Submission on Modification to Vincentia District Town Centre - Stage 1 - MP 06_0025 MOD 5

Executive Summary

2.4 NW Entrance

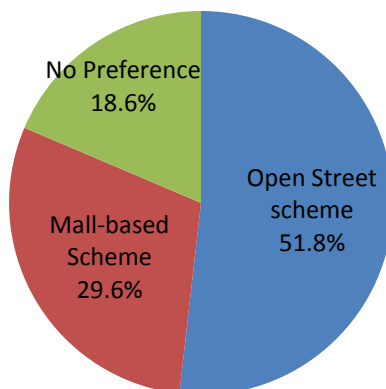
The main NW car park entrance off Moona Creek Rd has the potential to be excessively busy due to traffic now being diverted from the S entrance point on The Wool Rd, along with the proposed access to a service station and fast food restaurant. The close proximity of the Moona Creek Rd entrance point to the Naval College Rd roundabout increases the likelihood of traffic congestion on Naval College Rd. A similar planning problem is encountered in South Nowra where McDonalds and Caltex are situated close to the Princes Hwy roundabout and queuing traffic backs up into the highway.
